Supplementary

SERVICE MANUAL

MODEL VL-8

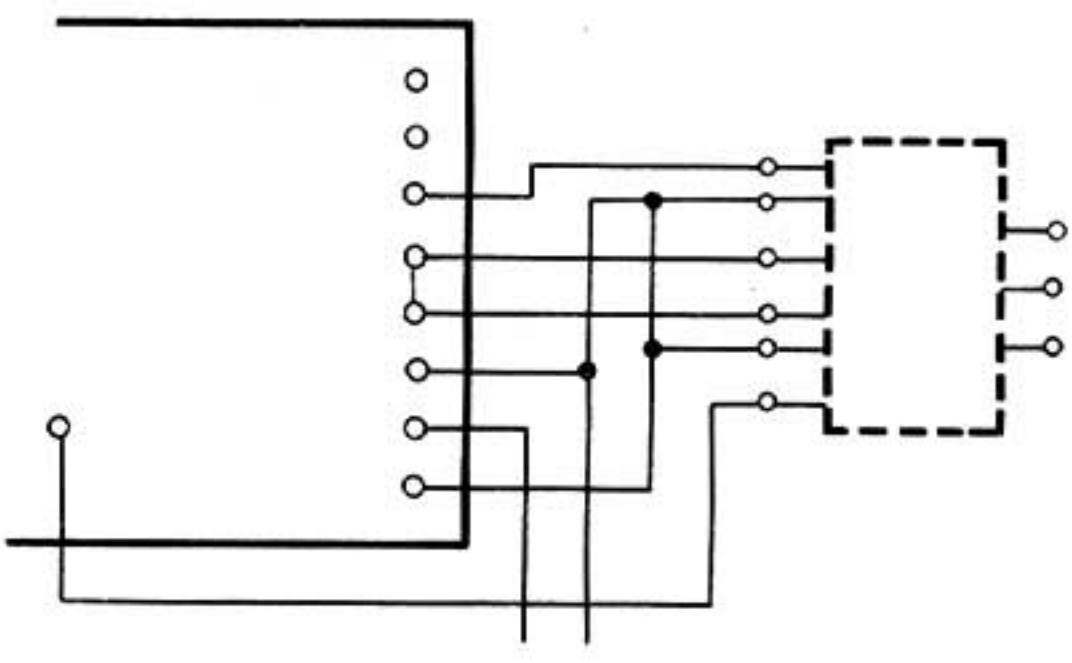
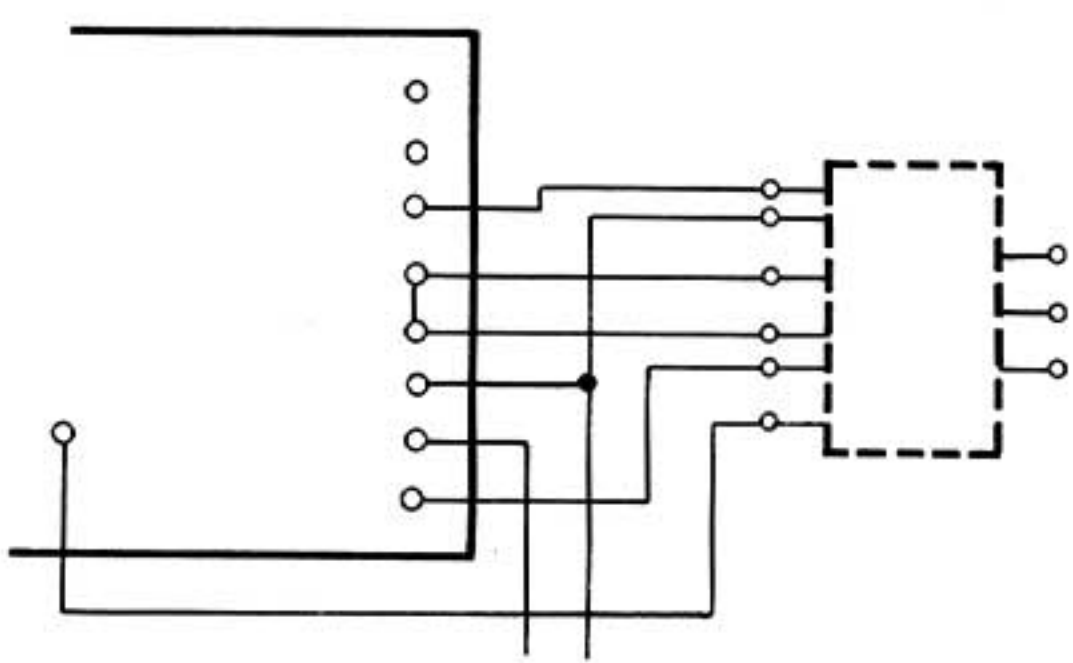
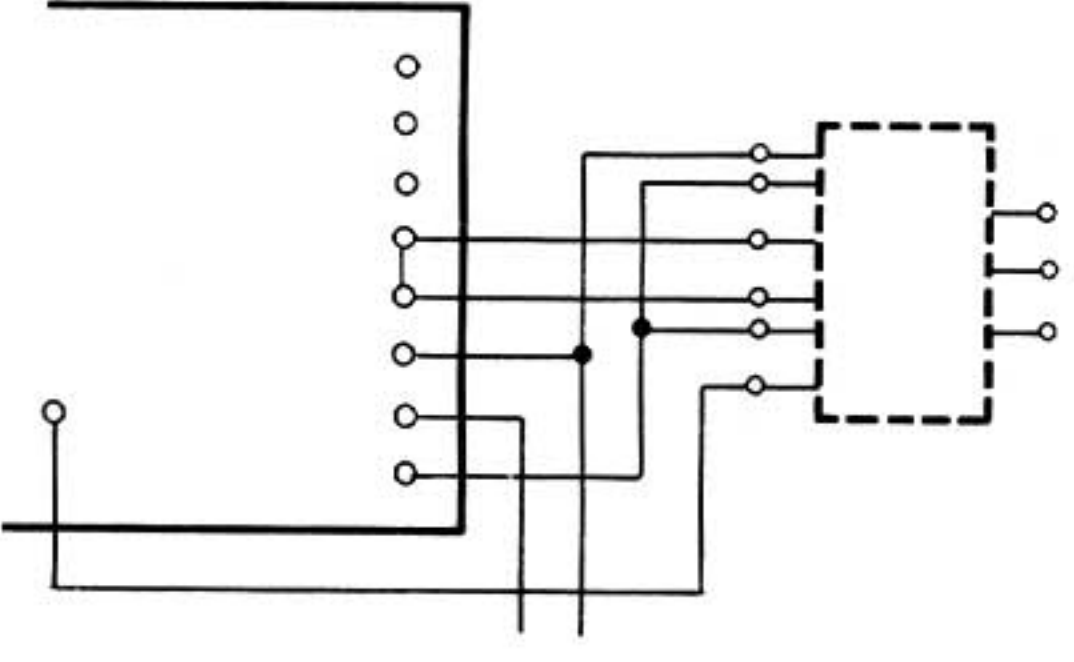
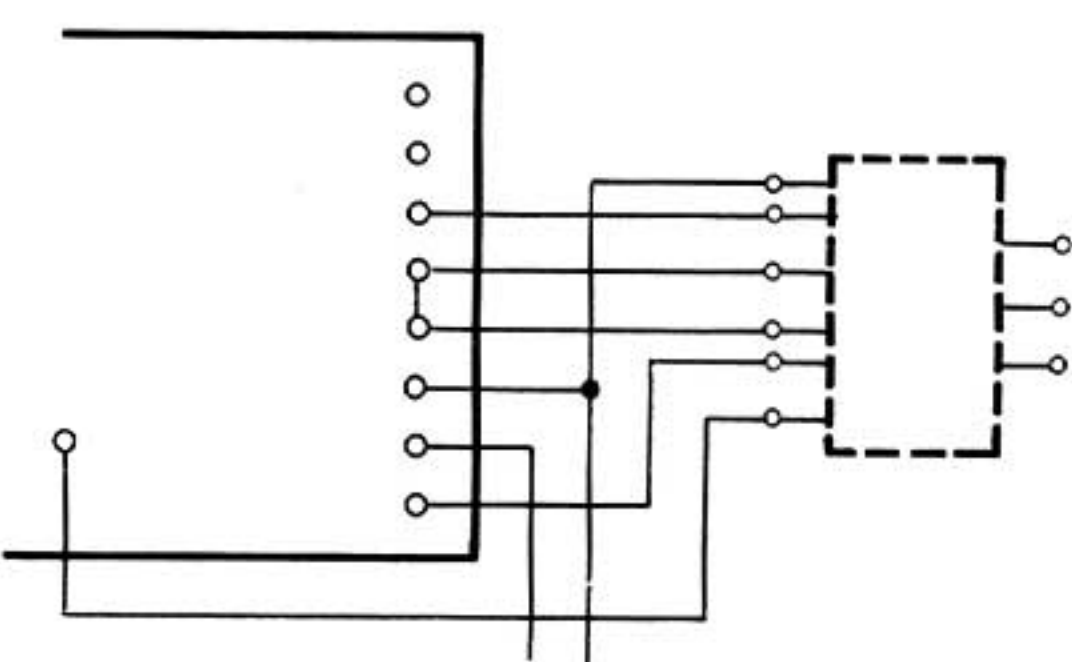
Two of the illustrations shown in the section "VOLTAGE CHANGE" of the SERVICE MANUAL No. 2294 for the VL-8 are incorrect.

When you use this SERVICE MANUAL please see the correct illustrations below.

ORIGINAL	CORRECTED
<p data-bbox="588 1397 746 1428">220V ZONE</p>  <p data-bbox="531 1907 756 1938">AC 220, 50/60Hz</p> <p data-bbox="316 1938 419 1968">Fig. 7</p>	<p data-bbox="1447 1413 1604 1443">220V ZONE</p>  <p data-bbox="1389 1938 1614 1968">AC 220V, 50/60Hz</p>
<p data-bbox="562 2044 719 2075">240V ZONE</p>  <p data-bbox="500 2548 746 2578">AC 240V, 50/60Hz</p> <p data-bbox="306 2578 408 2609">Fig. 8</p>	<p data-bbox="1430 2044 1588 2075">240V ZONE</p>  <p data-bbox="1379 2563 1624 2594">AC 240V, 50/60Hz</p>
